Planning & Zoning Commission Agenda Wednesday, September 16, 2020, 7:00 p.m. Via Zoom Virtual Meeting Posted September 10, 2020

CITY OF KIRKWOOD PLANNING AND ZONING COMMISSION SUBCOMMITTEE REPORT SEPTEMBER 16, 2020

The applicant is requesting Site Plan Review for a 12-unit condominium development. The existing properties contain two commercially-occupied buildings that were both converted from their original residential use. The proposed plan would demolish the existing buildings and place a four-story building with an underground parking garage that provides 24 parking spaces. The underground parking garage is proposed to be accessed via a two-way drive lane from Madison Avenue that would be shared with the Barclay development at 204 S. Clay Avenue. The proposed multi-family use is a permitted use in the B-2 District because the site is not located on a "Suggested or Mandatory Commercial" street in the Downtown Master Plan's Framework Plan.

SITE PLAN EXISTING CONDITIONS

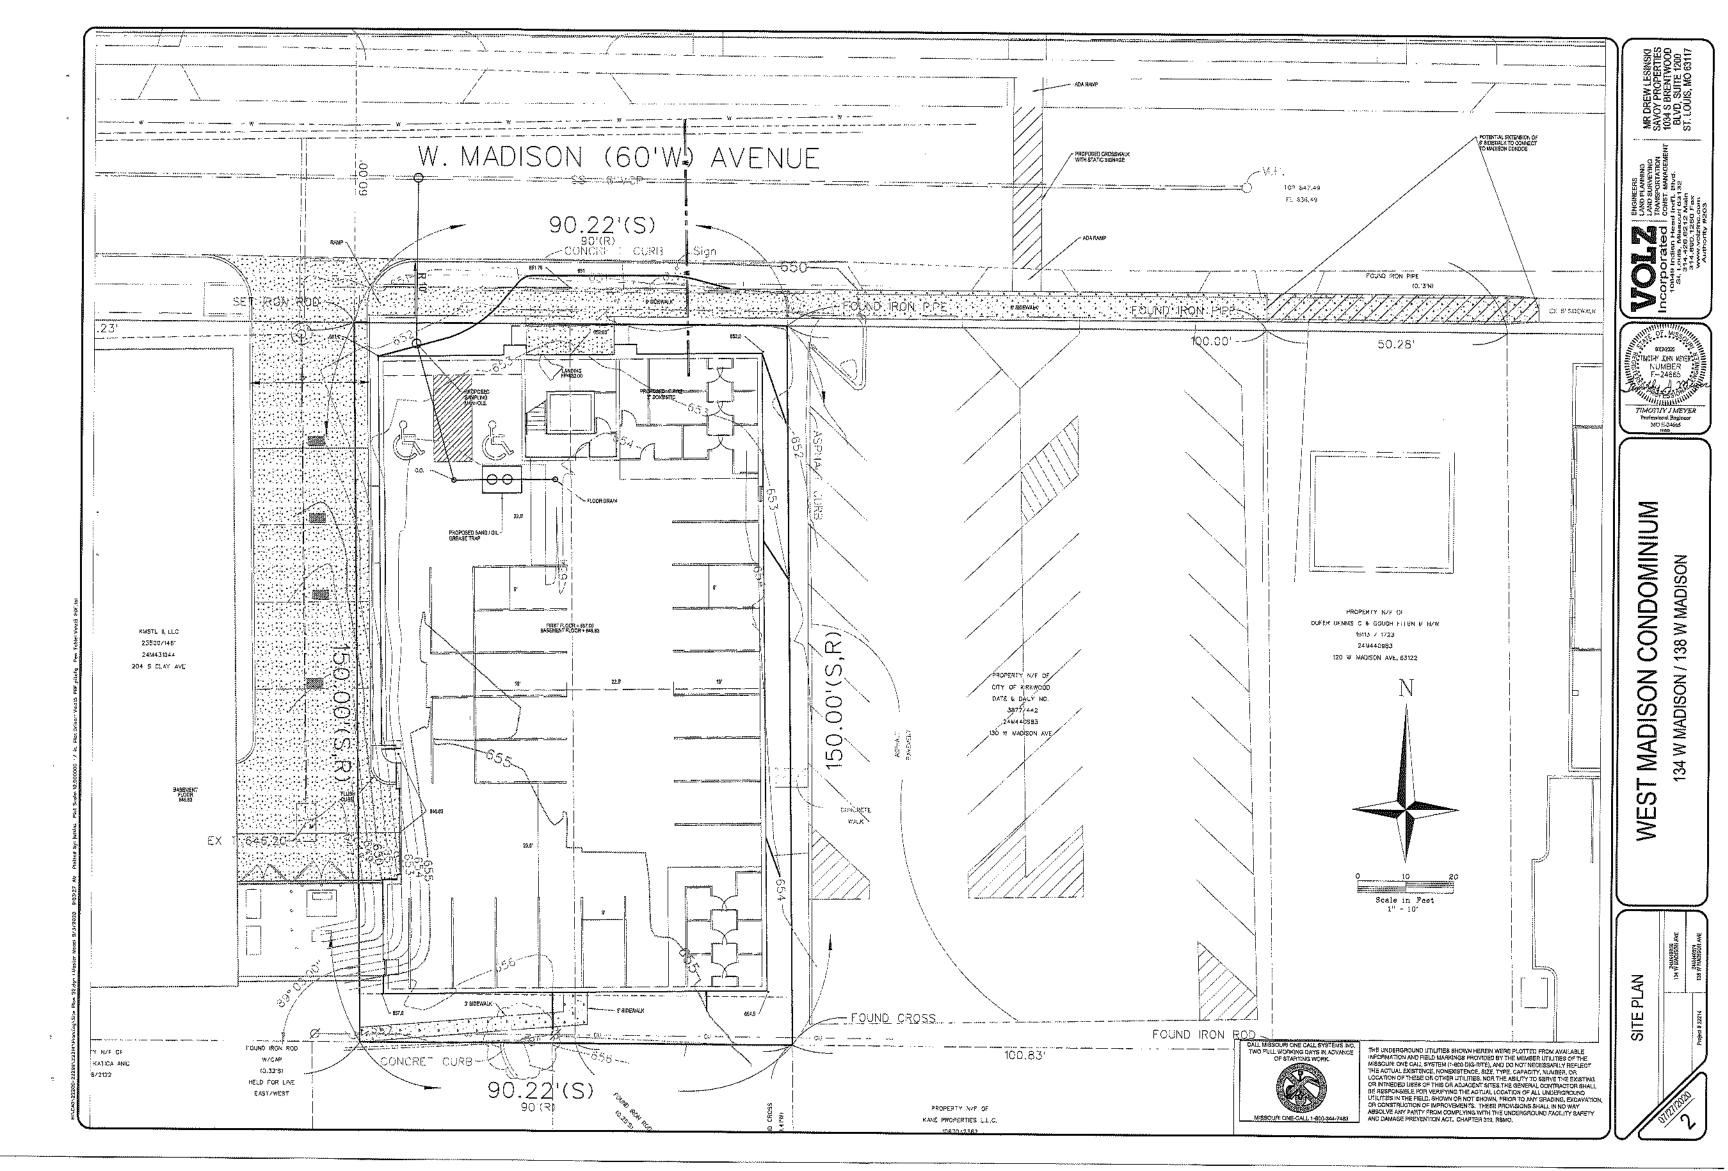
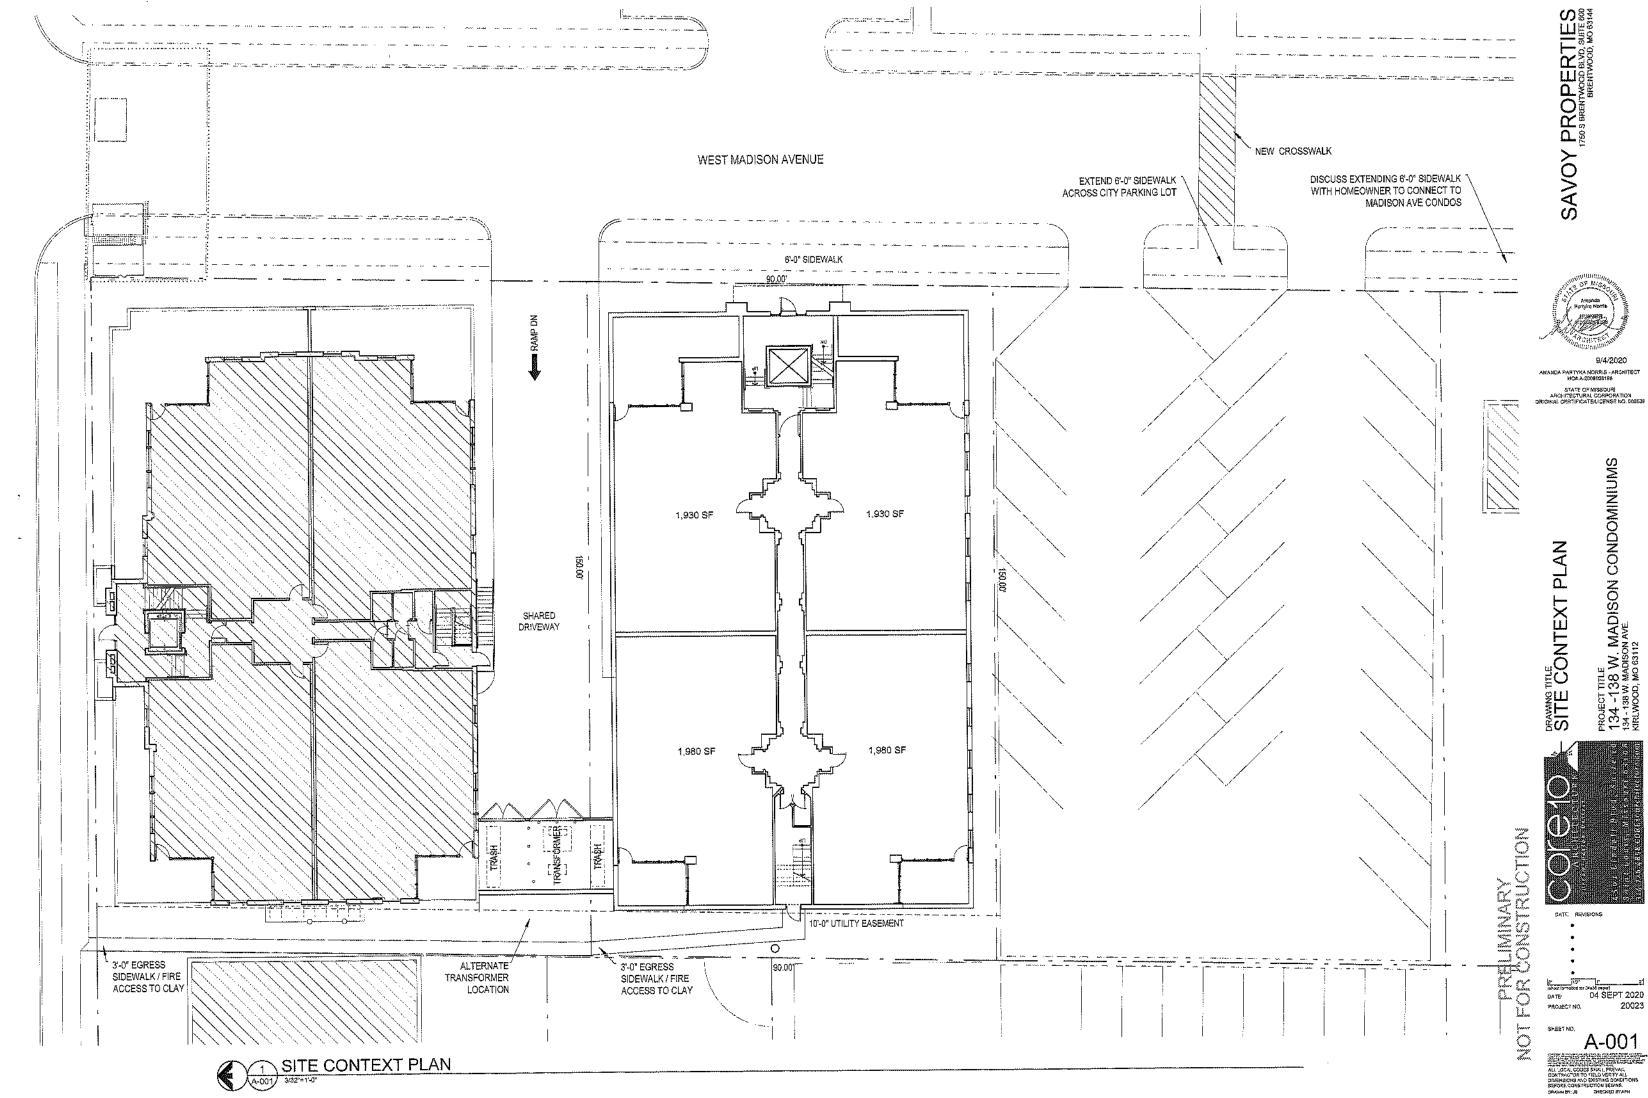
- See attached revised plans dated September 4, 2020.
- Sheet 1 of the Volz plans must be revised to reference the current parking requirement of 1.5 spaces per unit in downtown.
